**RE: SINGLE RESPONSE TO AMENDED PLANS – DA2023/0246, NO. 18
HILLCREST AVE, MONA VALE**

DA2023/0246

| DA description: | Alterations and additions to residential development – construction of a secondary dwelling. |

Figure 3: Suggested new location of the proposed secondary dwelling (Source: Amended Plans registered 29 June 2023 / iObject 2023)

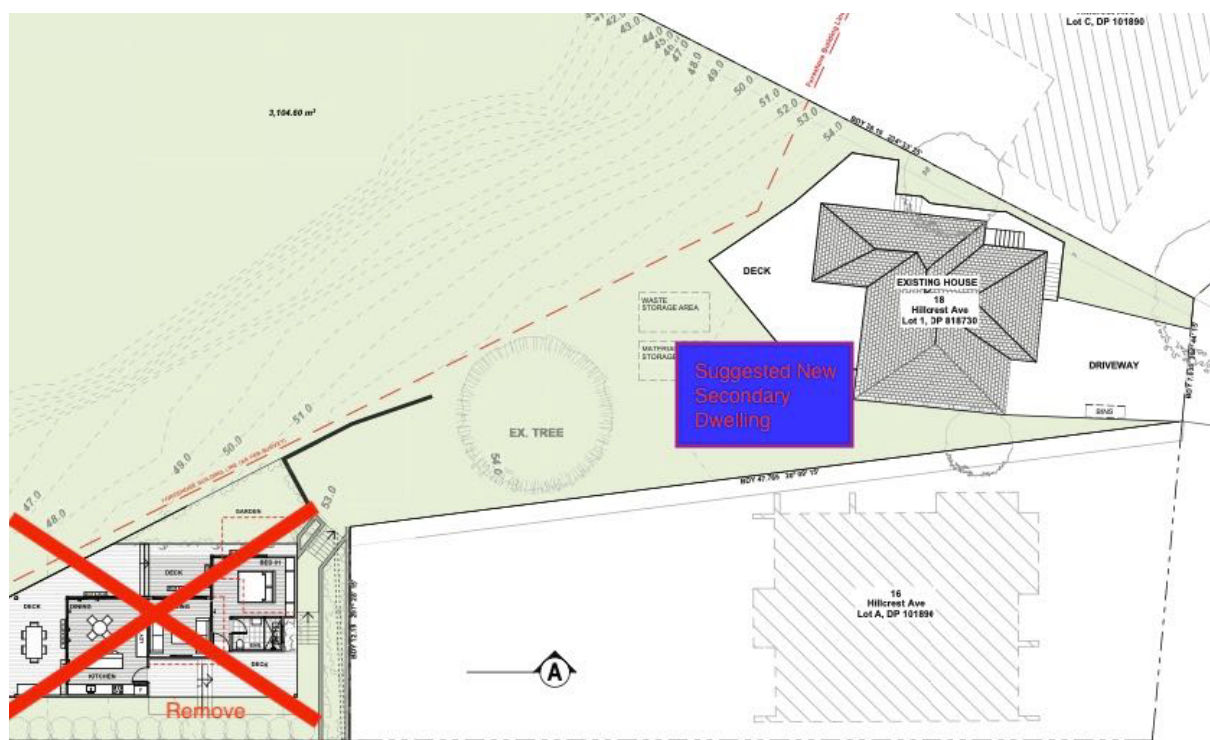
The amended plans continue to propose DCP non-compliances in relation to access and parking, with the absence of a driveway preventing the safe and convenient access to the secondary dwelling. Furthermore, the lack of additional on-site parking provision would likely add further pressure to on-street parking demand, which is already facing local pressure.

Notably, visitors to the Bicentennial Coastal Walkway attracts additional tourist parking demand, creating supply issues along Hillcrest Avenue at various times throughout the week. With inadequate parking unable to meet the demands generated by the development, the revised proposal thus cannot be justified on merit.

Proposed Solution: Reconfiguration of the proposal by integrating the secondary dwelling into the design of existing main dwelling (eg. via attached additions), where acceptable parking and driveway provision can occur.

Figure 4: Condemned Beach Track over the bluff face (Source: iObject 2023)

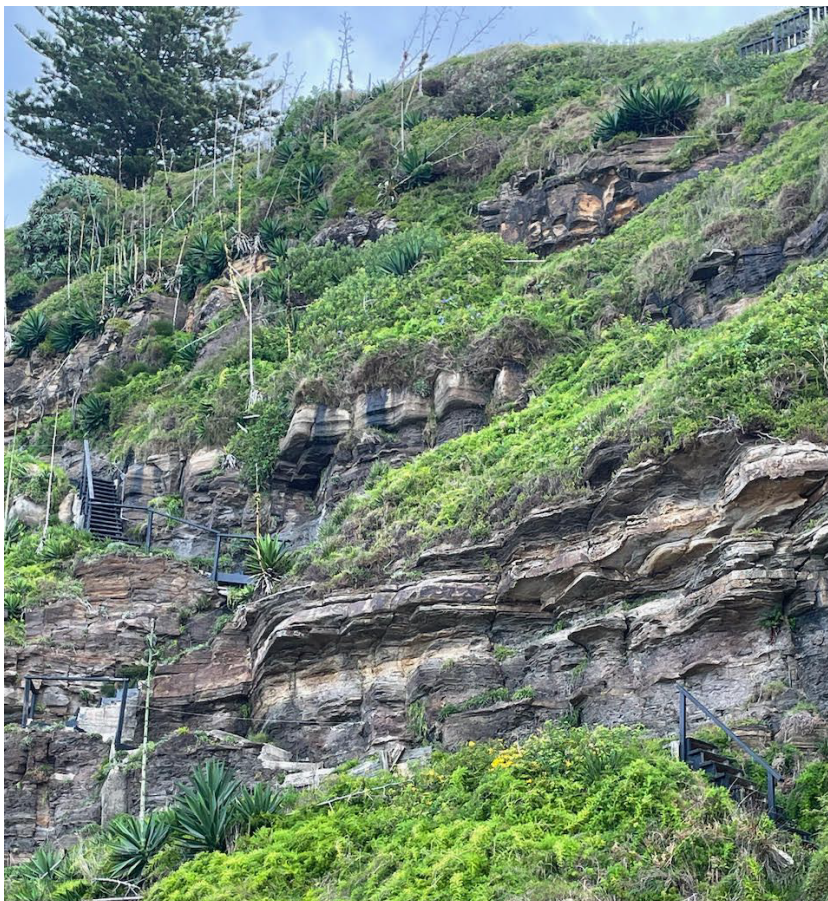
In the interests of ongoing safety and public liability, a serious response is required from Council in relation to the Cliff Track issue. Council has been made aware of the historic fatalities occurring between its land and the subject site, as detailed in iObject's Principal Objection. Informal reinstatement of the condemned track by the applicant is highly probable, thus necessitating Council intervention.

Given the topography and history of the site, Council may be liable for negligence should the amended structure be found to compound landslide risk at this location. Evidence of local cracking and movement highlights this possibility, offering a clear picture of the tenuous soil structure under which the Cliff Track is located.

- That Council's Compliance Team investigate the matter urgently as a matter of public safety.
- That any future approval on the subject site conditions a continuous fence with no opening at the entry of the condemned track.
